A PROJECT FOR:  
**Cason Graye Homes**  
PROJECT LOCATION:  
4805 Elm Street, Bellaire, TX.  
Lot 1 Block 1  
Subd. Wheelshire

DATE	CHECK SET	CITY COMMENTS
MA 12/8/2021		
MA 2/18/2021

SHEET NO.  
**1** OF **11**

front elevation

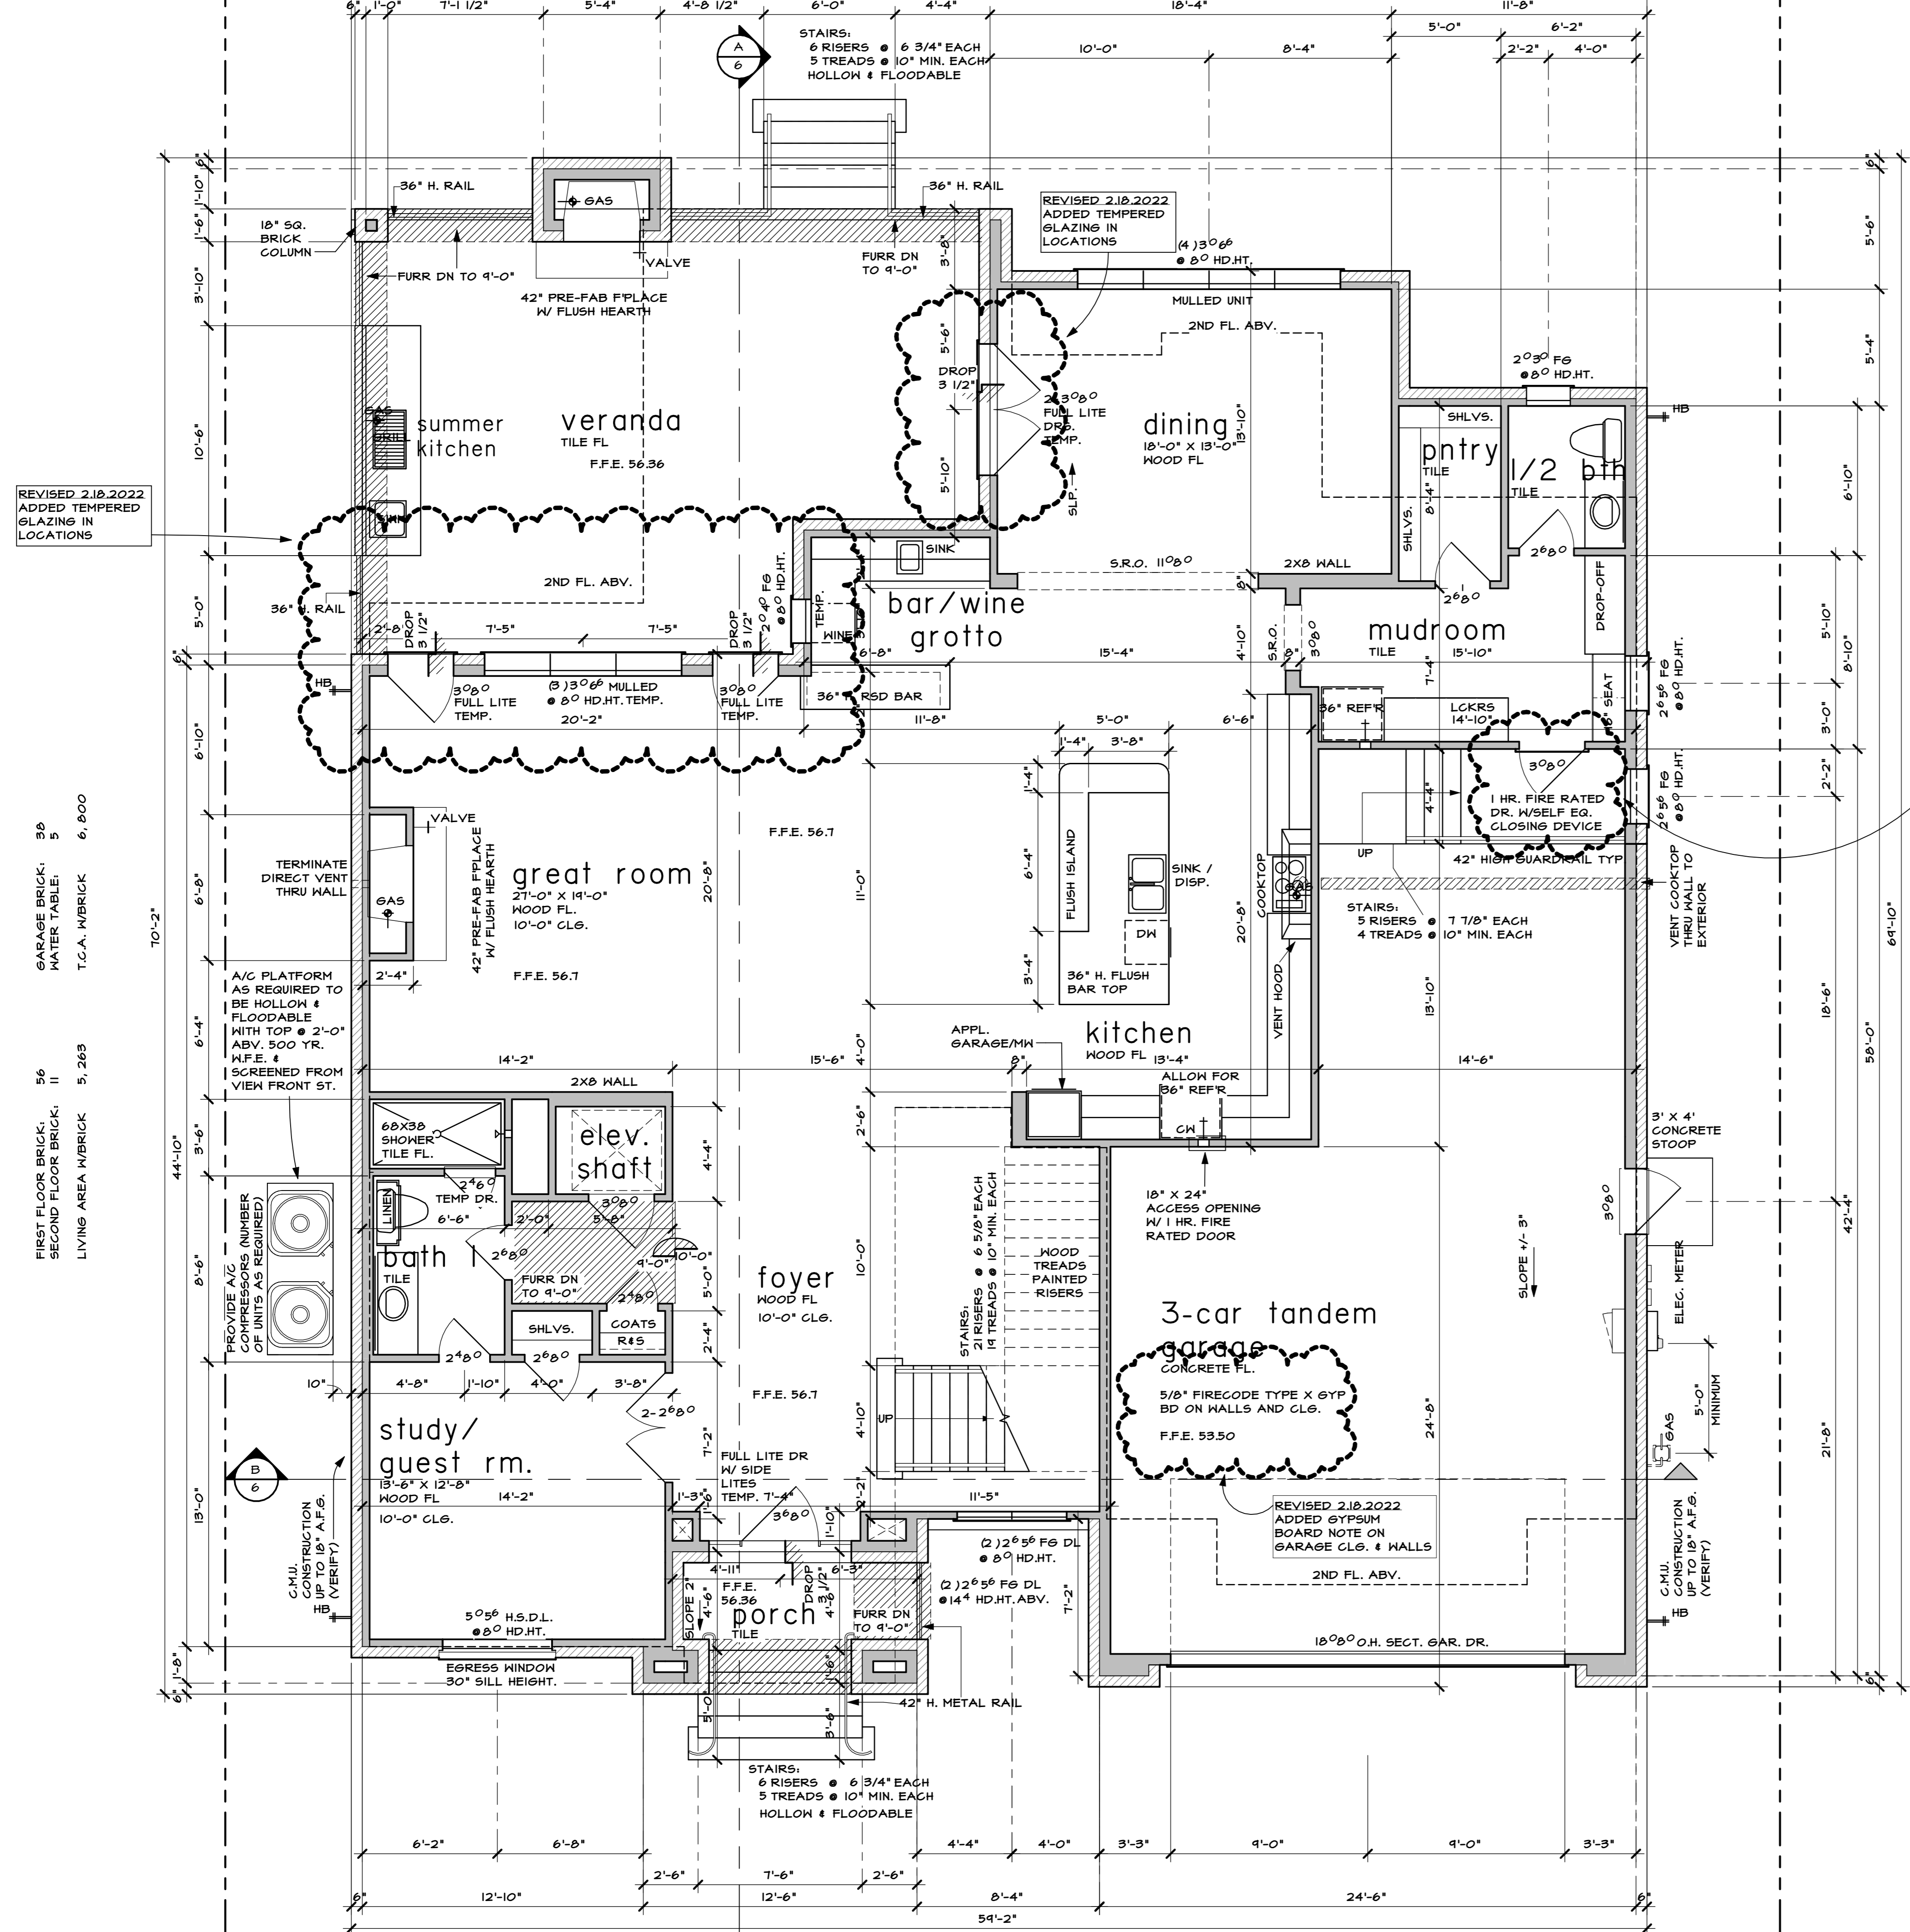
REVISED 2.10.2022  
ADDED TEMPERED  
GLAZING IN  
LOCATIONS

REVISED 2.10.22  
ADDED CITY OF  
BELLAIRE VAPOR  
BARRIER NOTE.

REVISED 2.10.22  
ADDED CFM NOTE FOR  
KITCHEN VENT HOOD

REVISED 2.10.2022  
ADDED NOTE FOR  
DOOR BETWEEN  
GARAGE AND  
DWELLING PER IRC  
R302.5.1

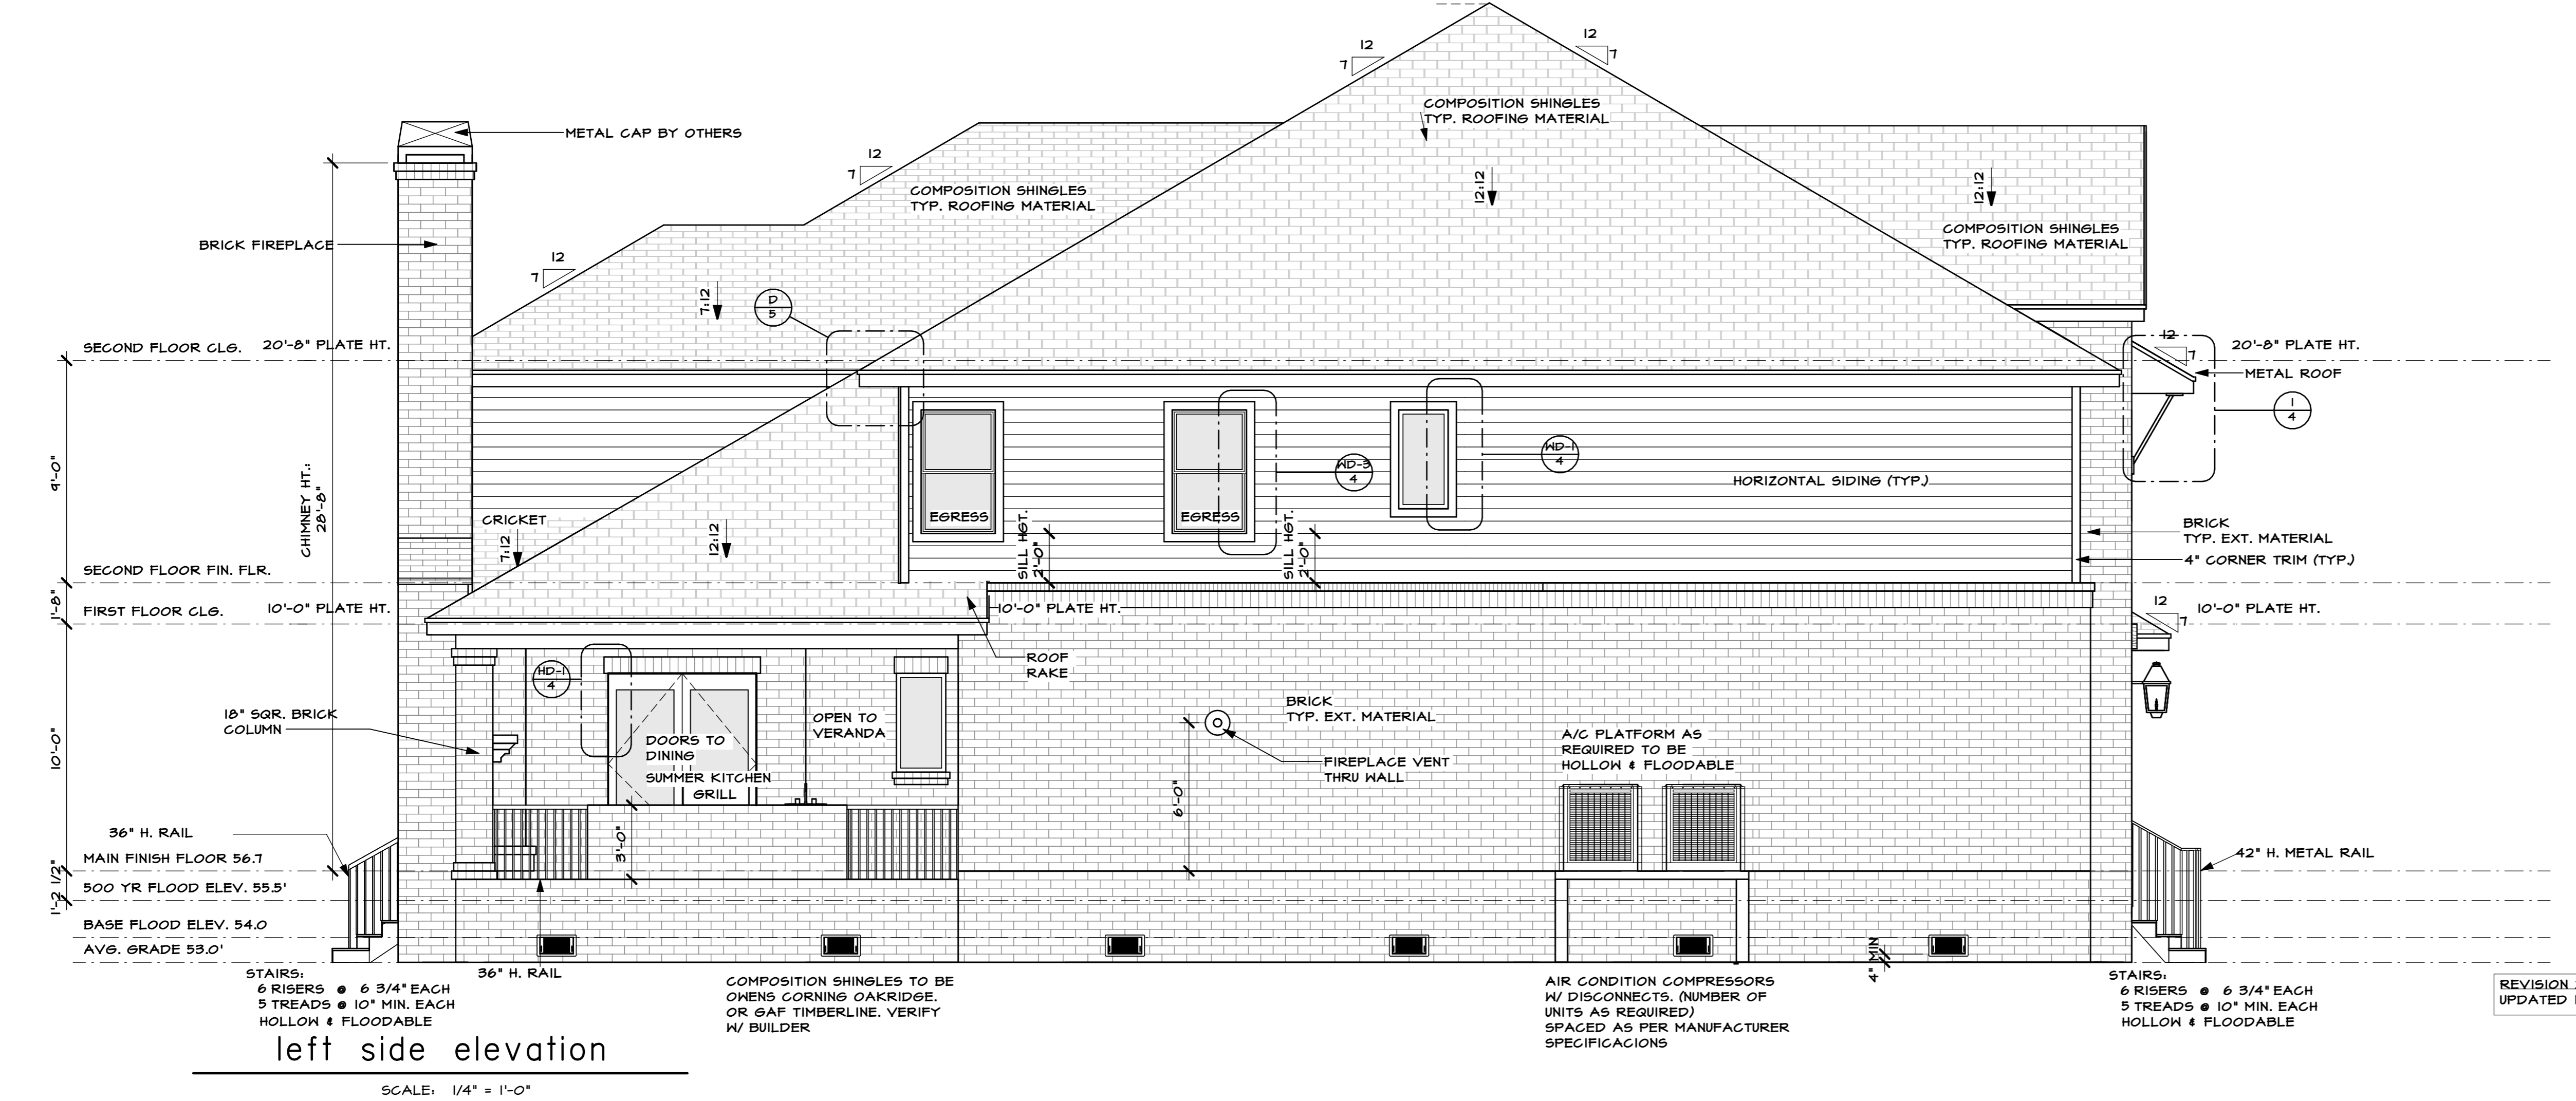
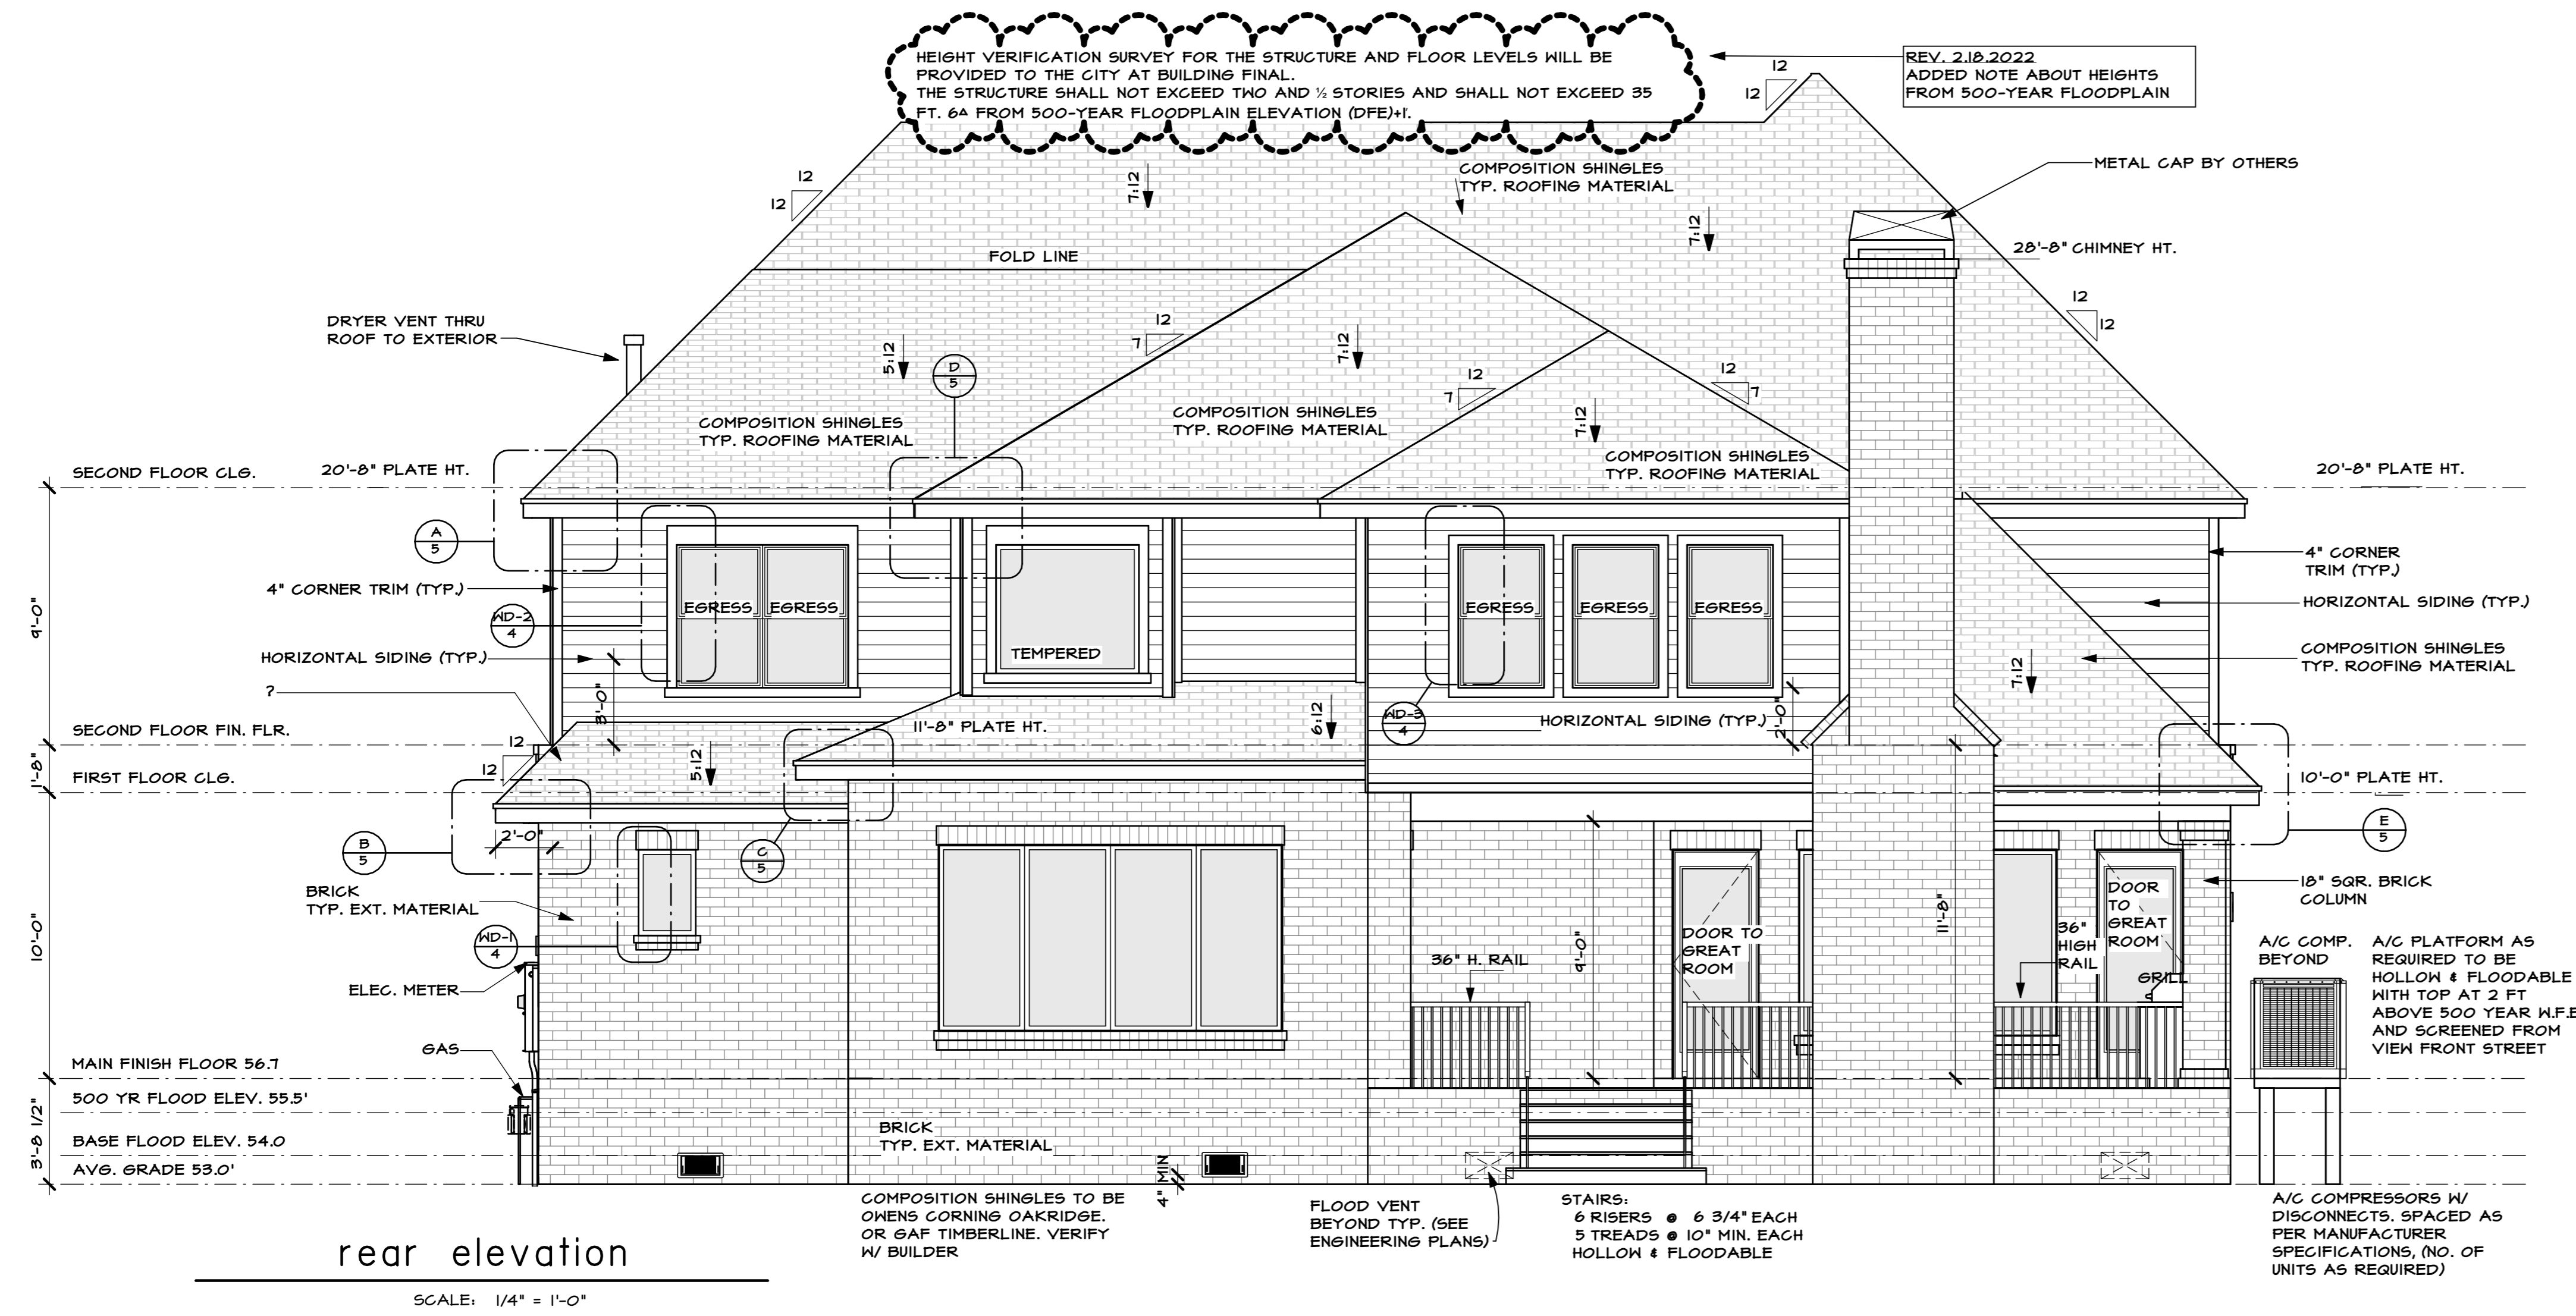
REV. 2.18.2022 ADDED NOTE ABOUT HEIGHTS FROM 500-YEAR FLOODPLAIN

HEIGHT VERIFICATION SURVEY FOR THE STRUCTURE AND FLOOR LEVELS WILL BE PROVIDED TO THE CITY AT BUILDING FINAL. THE STRUCTURE SHALL NOT EXCEED TWO AND 1/2 STORIES AND SHALL NOT EXCEED 35 FT. 6A FROM 500-YEAR FLOODPLAIN ELEVATION (DFE)H.
